Olin Corporation

Memorandum

Subject: Response to USEPA Memo dated Nov. 29, 2018 – Resolution of CSM

**Figure A.** TOR based on borings and the direct push data from Table 2.2-3 of the Draft RI. Note that SB-8 is equivalent to MP-4.

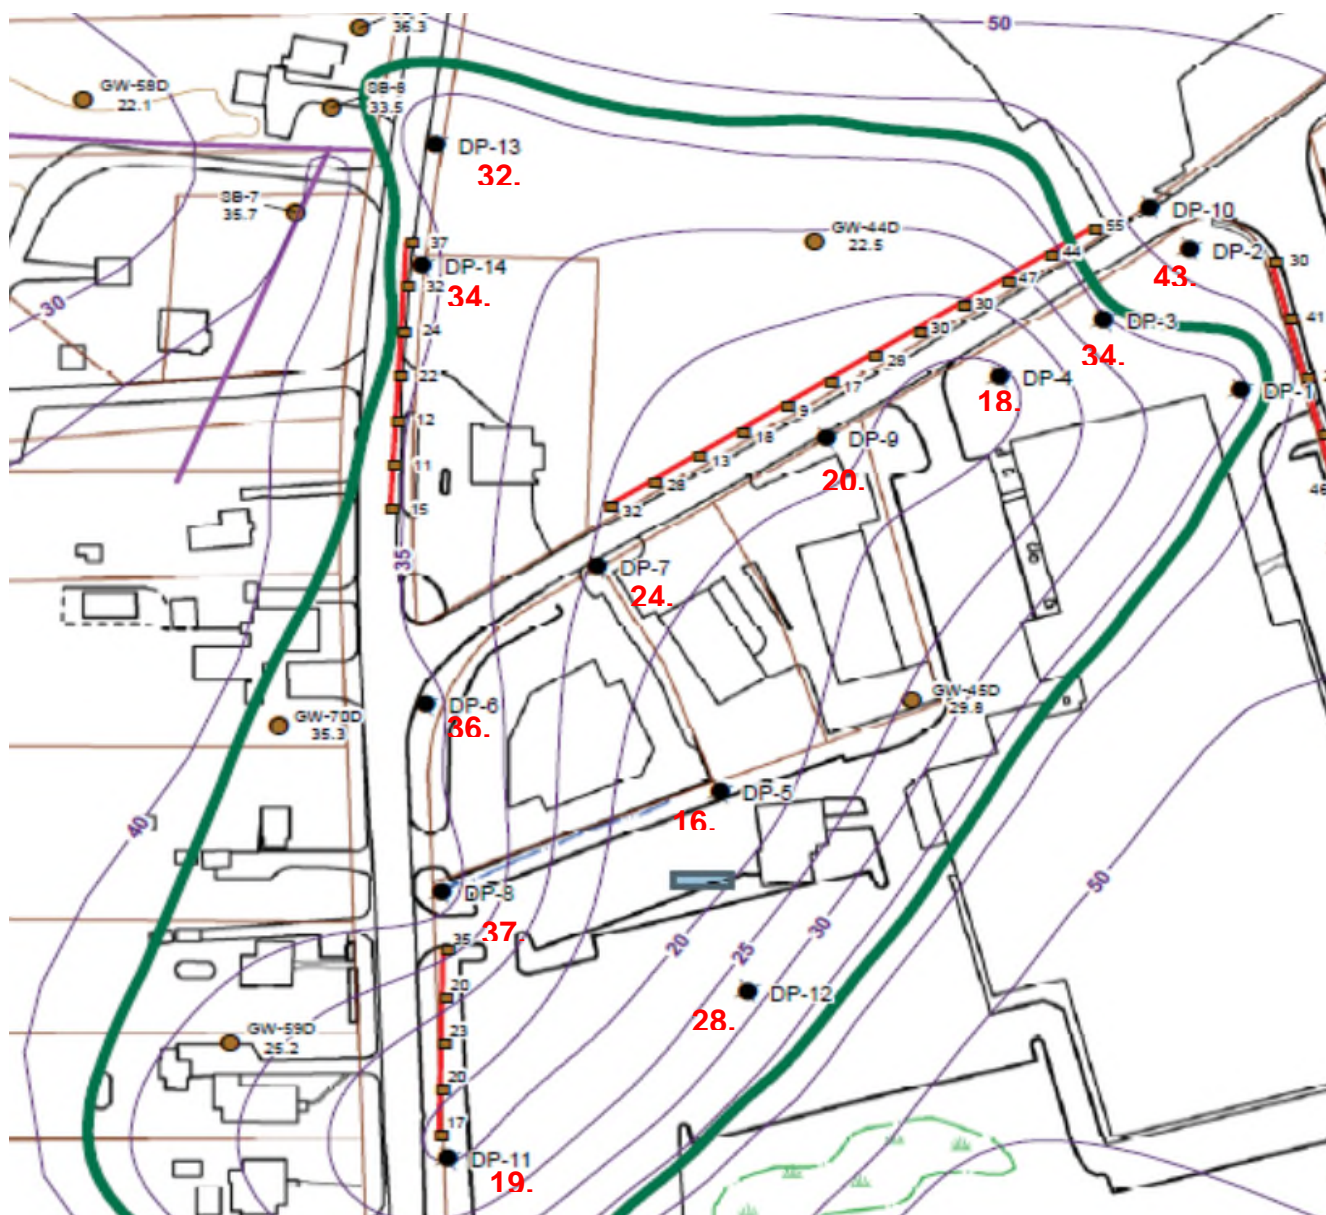
**EPA General Comment #4:** Lateral and vertical resolution on TOR surface: Frank acknowledgement of such resolution issues is needed to assess the *adequacy* and *uniqueness* of the interpretations which have been used historically to define the “Main Street DAPL pool”, “Main Street Saddle”, and other similar features of note at the Site. It is USEPA’s observation that the complexity of the bedrock surface is more variable than these simplistic interpretations allow. For example, upon examining the bedrock surface map created for the Main Street area by Geomega, and later revised by USEPA, the presence of crenulations and variability on the TOR surface over lateral distances of 10’s of feet are seen in nearly all areas where seismic reflection data was collected with a relatively close geophone spacing (~ 30-foot spacing). On the other hand, where data density is low, resolution of second-order features on the TOR surface is limited at best. This suggests lateral variations on bedrock elevation on a similar scale (or finer) than the lateral spacing of the characterization data points should be expected. On the other hand, the technical basis for the “Main Street saddle” is based on three borings spaced on the order of 75 to 100 feet apart, laterally. Clearly such a sparse lateral spacing is not commensurate with the level of variability observed in nature at OCSS or the level of resolution offered by other laterally-integrative methods such as seismic reflection. It must also be acknowledged that there are large swaths of area on the interpretive TOR surface used to define the “Main Street Saddle” and “Main Street DAPL pool” where there is no data of any kind. These issues of lateral resolution and data deficiency also call into question the validity and uniqueness of the interpretations which have been used to define the other DAPL

**EPA General Comment #5:** Alternative Conceptualization of DAPL “Pool” areas: Based on the foregoing discussions, it may be more appropriate to conceptualize the major *general* areas of DAPL accumulation as composite *source areas* with many *smaller laterally disconnected depressions* in which DAPL has accumulated rather than large monolithic basins. As such, all depressions on the TOR surface need not be characterized identically as uniform, unfractured, and “tight” (i.e., impervious) which inhibit DAPL penetration to greater depths. As will be discussed in the comments below, data do not support this overly simplified model. Instead, the larger-scale depressions may simply reflect an area - which at finer scales of investigation - reveals many distinct crenulations and depressions of varying dimensions and inconsistent elevations. Fracturing may or may not connect the TOR surface in these crenulations with deeper parts of the bedrock system. The attached Figure 1b., presents such an alternate CSM for areas of DAPL accumulation, similar to the Main Street DAPL area, for comparison with the generalized DAPL pool CSM presented previously by Olin (Figure 1a). Additional comments, below, will address the technical merits for these competing conceptualizations relative to features of interest, starting with the Main Street DAPL pool.

***Olin Response to USEPA General Comment #4:*** *The seismic data are generally in good agreement with the TOR identified from bore logs (see Comment #8; **Figure B**). However, seismic data, in general, provide a semi-quantitative interpretation and as such the bore logs should be the ultimate harbingers of the bedrock surface.*

*USEPA's CSM (Figure 1b) does not appear to incorporate available relevant data. For example, **Figure A** shows the base of the Main Street DAPL pool using all available data. This figure shows the TOR topography, which clearly indicates the presence of the bedrock saddle.*

USEPA's statement that there is "no data of any kind" is not accurate (see Response to USEPA General Comment #8 – 2<sup>nd</sup> Paragraph below). While we concur that additional data could aid in refining the location and elevations of the Main Street saddle, we believe this requires careful consideration of strategic data quality objectives.

**Figure B.** TOR based on seismic data compared to boring logs. The average error is  $\pm 2$  ft ( $n=21$ ). Note that there is also a reasonable correlation where direct push bores (e.g., DP-8, -11 and -14) are adjacent to seismic data.

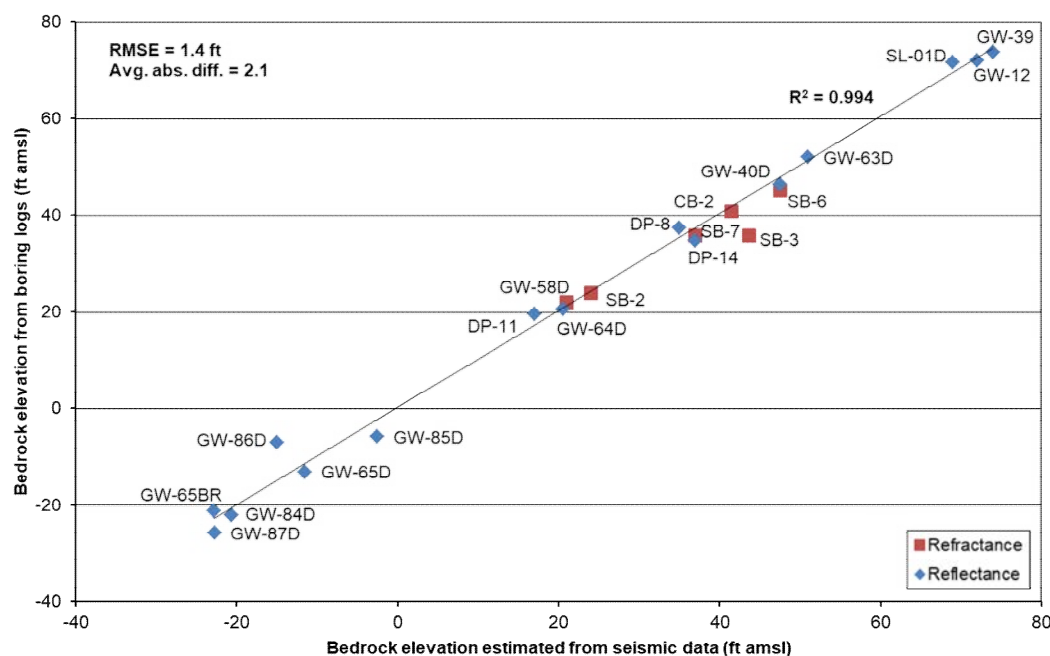
**EPA General Comment #6:** TOR Elevation Uncertainty - Main Street Area: Uncertainties on the data elements used to map TOR surface were discussed in some detail in USEPA’s November 15, 2018 memo, entitled, *Follow-up to Meeting of October 25, 2018: Reevaluation of Technical Basis for “Main Street Saddle” and related CSM elements, initial response*. The following table compiles and summarizes this information:

Data type	Vertical resolution	Comment	Olin Response
direct push boring (geoprobe)	<1-10+	Potential error bar can be large due to potential drill string drift, “false positive” identification of bedrock at shallow “refusal depth”, etc. Error usually biased high, i.e., to (falsely) higher bedrock elevations than actual conditions.	<b>Olin Response:</b> <i>This is incorrect. Drill string drift only accounts for a ~1% deviation (Twining, 2016).</i>
soil boring or MW (no core samples)	<1-5+	Degree of resolution dependent on core recovery and coring methodology. Lack of confirmatory core can result in large errors due to mis-identification of boulders as TOR, false/premature refusal depths, etc. Note that boulders were identified during slurry wall construction and in a number of boring logs around the OCSS, so in this case, boulders are a serious non-hypothetical concern.	<b>Olin Response:</b> <i>Comparing seismic data versus the TOR from adjacent (within ~20 ft) cores demonstrates good agreement (Figure B below).</i>

**Olin Response to USEPA General Comment #6:** While Olin agrees that 10% is a reasonable error bar for seismic refraction from an academic perspective, in practice when locations with confirmatory adjacent bores (within ~20 ft) are compared to the seismic TOR, the agreement is typically within 2-3 ft (**Figure B**). Of more relevance is that the methods appear to align well ( $\pm 2$  ft), providing valuable information on the TOR configuration across the entire OCSS. These data demonstrate that the USEPA's estimate (10+ ft) may be incorrect. Further, the seismic refraction and confirmatory adjacent borings confirm that the collected data complement each other, confirming the fact that the data utilized to develop site CSM are robust.

**Olin Response to USEPA General Comment #8 (1<sup>st</sup> Paragraph):** *Olin questions the accuracy of the error bars portrayed by USEPA appear to be arbitrary and speculative. USEPA has provided no technical foundation or reference back to the scientific literature. With specific reference to Figure B, the average error is  $\pm 2$  ft, which is inconsequential to the overall accuracy of the CSM.*

**Figure C.** a) Data defining the TOR in the Main Street area. Note that TOR in SB-3 (Law 1999) has been re-interpreted to be at 36.7 ft amsl, and b) The USEPA's "spillway" and "south drainage way" locations in relation to SB-6 and GW-59D, respectively.

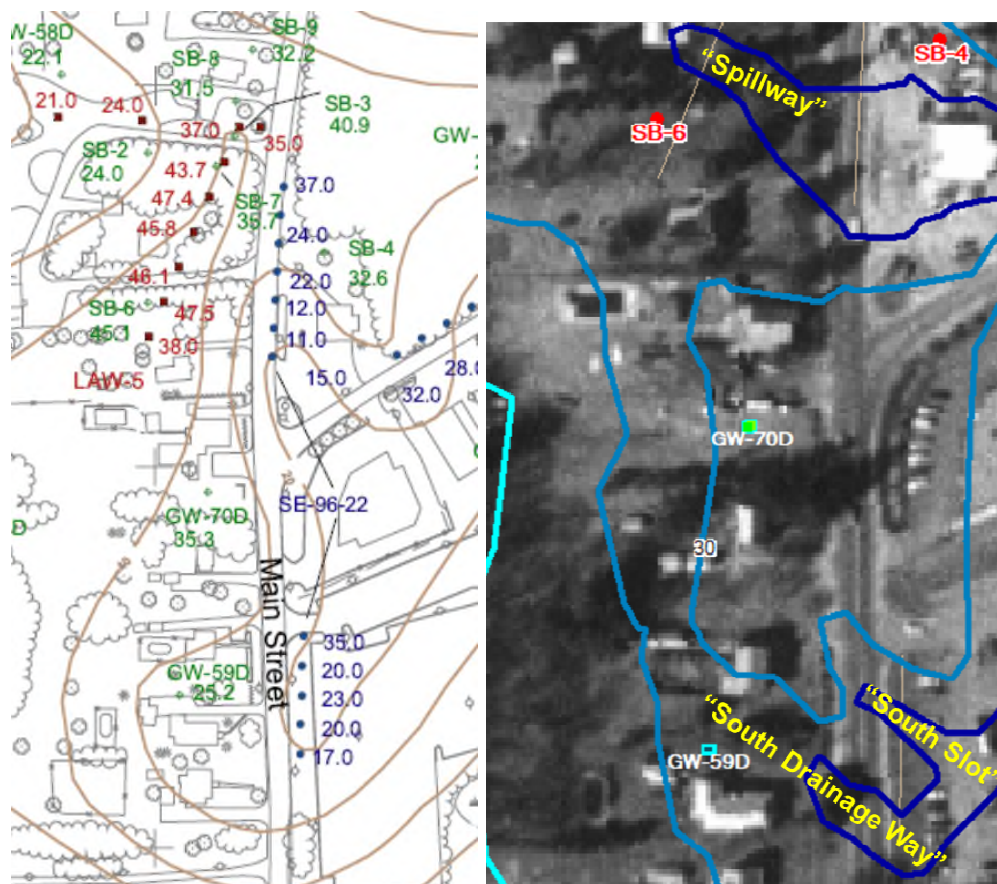
**USEPA General Comment #8 (2<sup>nd</sup> Paragraph):** This region is designated provisionally as the Main Street “Pinnacle”. As per this interpretation, there also appears to be a small disconnected depression on the bedrock surface in the general area of MP-3, which is designated provisionally as the Main Street “Chalice”, which USEPA interprets as an isolated depression of higher elevation than the average elevation of the Main Street DAPL pool. DAPL presence at this higher elevation may be due to its apparent morphology as a closed depression of smaller scale, possessing an interpreted comparatively “tight bottom” - with a relatively sparse degree of fracturing - that only allows for limited excursion/migration of DAPL, at slow rates.

The resolution of this feature is weak given the limited data to the north and east. Additional seismic data proposed in Recommendation 3, below, will help to clarify the presence and dimensions of this feature. In the revised interpretation, the “spillway” feature previously identified by USEPA has been moved slightly to the south to honor the seismic refraction data, but data quality issues have been identified with the refraction data, and a closer examination of that data does *not* support elimination of the “Spillway”. To the south of the “Spillway”, an additional area of relatively higher elevation bedrock, provisionally designated the “Plateau” has been identified. South of the “Plateau”, a smaller scale depression/trough designated as the “Southern Slot” has been identified and is located within a larger-scale depression herein designated as the “South Drainage way” feature. The potential importance of these low-lying valley-like features strongly suggests the need for further resolution in this southern part of the greater Main Street DAPL area.

**Olin Response to USEPA Comment #8 (2<sup>nd</sup> Paragraph):** Olin questions the accuracy of USEPA's CSM for several reasons. Apart from terms such as "chalice", "pinnacle", "spillway", and "plateau," for which there is little if any support, the interpretation fails to consider all of the available data.

USEPA's "pinnacle" appears to be based on boring SB-3; however, closer evaluation of that bore log suggests till/bedrock at an elevation of 35.7 ft amsl rather than the 40.9 ft amsl as posted by USEPA. USEPA's "spillway" is at an elevation of 35.7 ft amsl; however, the 2012 MP-3 DAPL cutoff was at 35.5 ft amsl. Regardless, it is apparent that historically DAPL has migrated through the till (as Olin has represented since 1999) based on the bore log description of "greenish rock," although the seismic reflectance data showed elevations of 43 ft amsl in this area, supporting Olin's contention that geophysics by itself may not provide the desired level of accuracy in this setting. USEPA's "south slot" and "south drainage way" are unsupported by any data.

In fact, the "south drainage way" is directly upgradient of GW-59D (**Figure C**). Although data is sparse, ammonia concentration at that location was 3.7 mg/L in 2004, three orders of magnitude lower than in DAPL. SB-6 was drilled directly adjacent (within 40 ft) to the USEPA's "spillway" location and was sampled from 56 ft bgs, comporting to the till/bedrock interface. The pH of this sample was 6.4, iron 4 mg/L, chloride 230 mg/L and sulfate 337 mg/L (Geomega 1999), clearly inconsistent with a DAPL pathway. The USEPA's CSM fails to include this data.

Referring to USEPA Figure 3, Area A is the most likely pathway for diffuse layer migration (note that downgradient GW-58D has diffuse layer characteristics). On **Figure C**, the low area is in the vicinity of SB-8 (MP-4).

**Figure D.** Induction logs for, a) GW-35D and b) GW-43D. Note that while the signal strength varied from year to year, the elevation of the peaks remained at a consistent elevation.

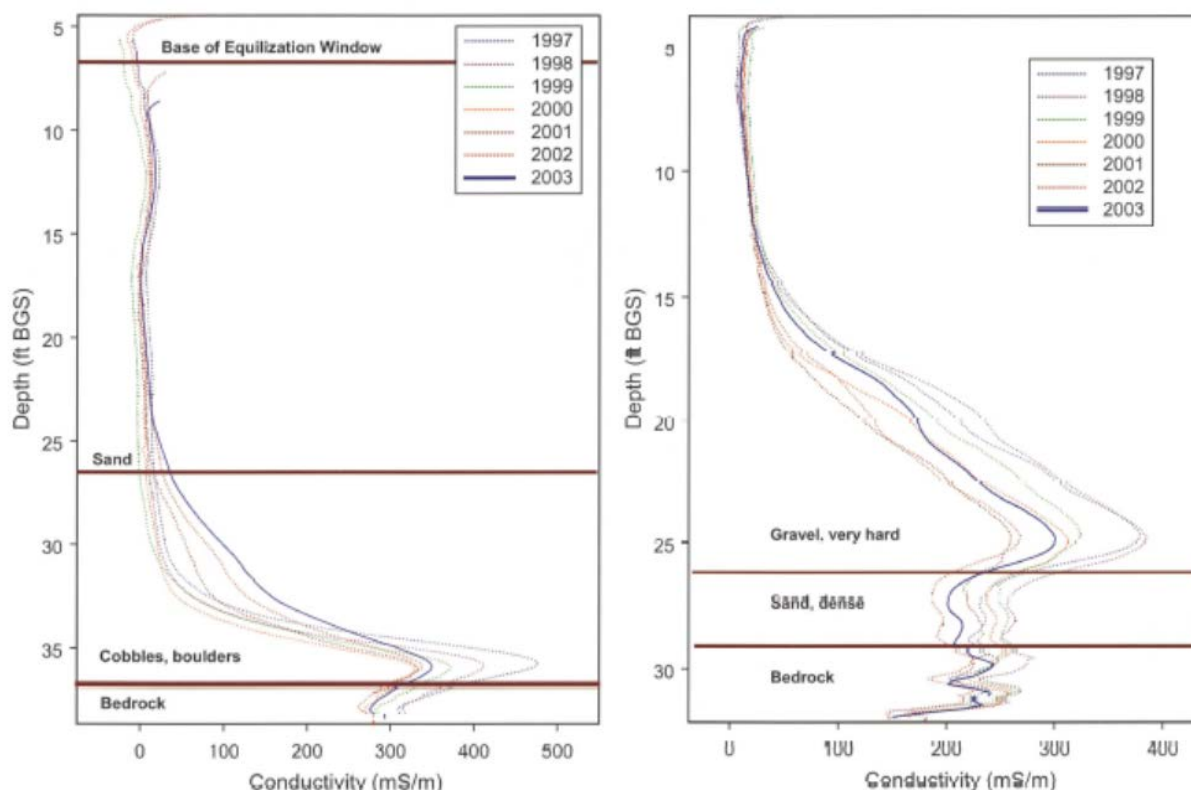
**USEPA General Comment #9:** DAPL measurement Error Bars, Issues, and Uncertainties:

USEPA's assessment concluded that the various approaches used to measure DAPL, although helpful for providing rough estimates of the volume, all have significant issues, error bars, and uncertainties associated with them. As such, they are not accurate enough to provide precise elevation depths and therefore, additional approaches will need to be employed in conjunction with follow-up efforts. As summarized above, these issues include the following:

***Olin Response to USEPA General Comment #9:*** *Olin disagrees with these error characterizations based on the data as described below as well as in response to USEPA Recommendation #4 (2<sup>nd</sup> Paragraph, Item B) and the affiliated figures.*

*The elevation of the DAPL pools has been assessed over the years. Inductance logging at multiple wells has shown consistent peaks in elevation rather than fluctuations, as would be the case if there was inherent error in the method. The USEPA claim that there is a greater than 5 ft of error in the top of DAPL elevation is unsupported.*

**Figure E.** Specific conductivity in ML1. The green dashed line represents the DAPL/Diffuse Layer cutoff at 20,600  $\mu\text{mhos/cm}$ .

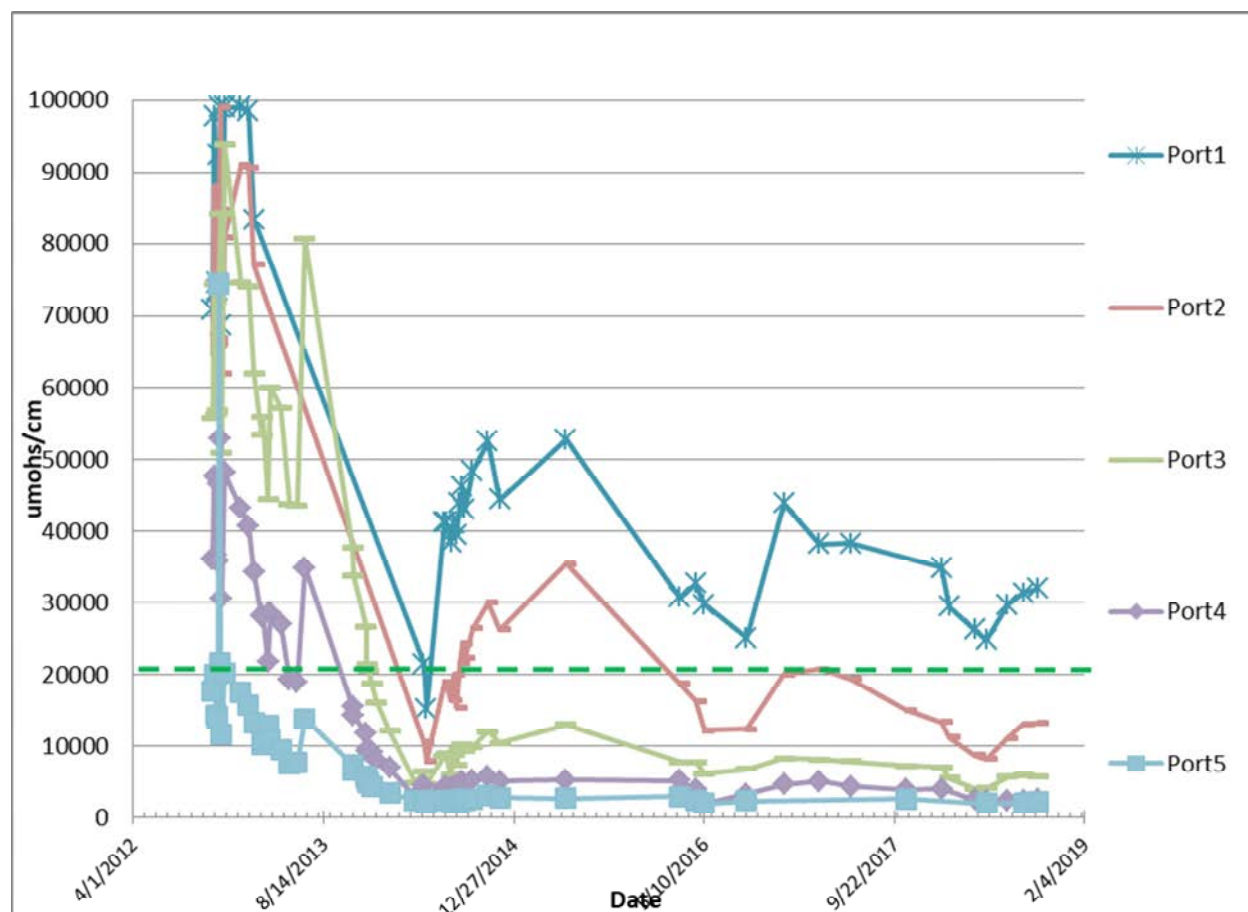
DAPL Estimation method	Vertical resolution (ft)	Error bar (ft)	Comment	Olin Response
Conductivity probe	0.05	1-10+	Magnitude of error bar is correlated with length of screened interval/sand pack in specific monitoring well.	<i>See Figure G</i>
Induction logging	0.1	>>5+	Dependent on specific dimensions of EM logging tool; further analysis is forthcoming. The likely confounding effects of reported solid precipitates (such as chromium sulfates) in the aquifer matrix relative to resolving DAPL elevation with Induction logging have not been quantified for this memo but will likely contribute to a larger error bar.	<i>See Figures D and G</i>
Direct DAPL sampling from multi-	1	1.5-6.5	Distance from screens ranges from 0.5 ft to 4.5 ft away from DAPL surface

Second, the DAPL elevation in the multi-port wells in the Jewel Drive area has responded in a predictable manner to DAPL removal. Based on the DAPL/diffuse layer interface (specific conductivity of 20,600  $\mu\text{mhos/cm}$ ), the DAPL level passed sequentially through port #5 at ~55 ft amsl in 11/2012, #4 at ~54 ft amsl in 11/2013, #3 at ~52 ft amsl in 12/2013 and #2 at ~51 ft amsl by 5/2017 (**Figure E**). All these data have been provided to the USEPA in the past. In addition, the induction log data (**Figure D**) reflect a tight control on elevation.

Third, the specific conductivity profile in MP-2 as of March 2003 compared to the inductance log in adjacent well GW-42D are well correlated, demonstrating that the USEPA's 1-10+ ft error bar affiliated with conductivity probe measurements is also incorrect (**Figure G**; Response #24).

**Olin Response to USEPA Recommendation #3 (2<sup>nd</sup> Paragraph):** *It is unclear why additional information is needed for the Jewel Drive DAPL pool as it has been depleted by ~4 ft between 2013 and 2017 (Figure E). Further, approximately, 30% of the pool has been removed and the removal is proceeding in general accordance with the approved design. However, as mentioned above, Olin will consider and evaluate other options in conjunction with EPA ORD to develop viable remedial alternatives for DAPL. Also refer to Figure F characterizing the Jewel Drive bedrock saddle.*

**Figure F.** Locations and revised bedrock TOR contours in the Jewel Drive area (Geomega 2003; Figure 1).

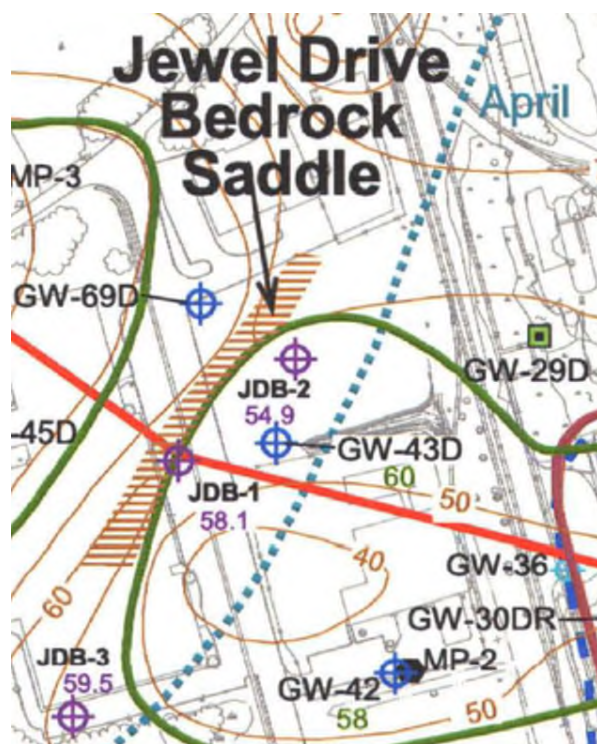
**USEPA Recommendation #3 (1<sup>st</sup> Paragraph):** Jewel Drive Top-of-Bedrock Surface: In the interest of improving DAPL extraction effectiveness, it is also critical to perform additional efforts to produce a more highly resolved map of the TOR elevation relative to the following efforts in the Jewel Drive area: a) to provide a technically defensible foundation to a more robust, holistic analysis of extraction efforts to date; b) to support follow-up DAPL measurement assessments proposed in the recommendation, below, and c) ultimately to support design/installation of additional extraction wells or modification of existing wells as driven by the data. Experts from USEPA's Office of Research and Development (ORD) have begun an in-depth review of work-to-date towards the goal of developing strategies for optimized extraction of DAPL related to the Jewel Drive pilot test.

**USEPA Recommendation #3 (2<sup>nd</sup> Paragraph):** Current recommendations suggest short screened-intervals for extraction points, of as little as 1-ft in the vertical dimension may be more effective in allowing for sustained extraction. In this context, the need for a more highly resolved map of the TOR surface at Jewel drive becomes a high priority design data objective. A similar approach to that requested for the Main Street Area, above, is a starting point for discussions, but a higher level of resolution may be needed in the Jewel Drive area to support remedial design, including more precise placement of extraction well screened-intervals relative to TOR and DAPL elevations. A review of existing TOR data across the Site suggests that a methodology and implementation strategy which provides a level of vertical resolution of 2-feet or less and lateral resolution of 10 feet or less in all directions may be needed to achieve design objectives. Seismic reflection data should therefore be collected using a relatively fine grid spacing and tight geophone spacing. A 10-ft X 10-ft grid-spacing is proposed for the seismic reflection surveys as a starting point for discussions. The area to be surveyed at the specified higher resolution should minimally be a 200-ft X 200-ft box centered on EW-1. However, given

***Olin Response to USEPA Recommendation #3 (1<sup>st</sup> Paragraph):*** It is unclear whether USEPA reviewed or are familiar with the data and results of the Jewel Drive bedrock saddle investigation that was conducted April 2003 (Geomega 2003). Three rotosonic bores were advanced to bedrock. The TOR was determined to be at 58.1 ft amsl in JDB-1, 54.8 ft amsl in JDB-2 and 59.5 ft amsl in JDB-3 (**Figure F**) which both confirmed and refined the Jewel Street saddle TOR. In addition, data collected from MP-2 corroborate April 2003 data.

*As discussed above, further characterization is unnecessary at this time (Figure F). Olin is committed to source removal and/or reduction, but in a measured way which is practically feasible. Olin is willing to work with the EPA to develop a functional work plan that will help refine the site CSM as appropriate as well as to develop viable and practicable remedial alternatives.*
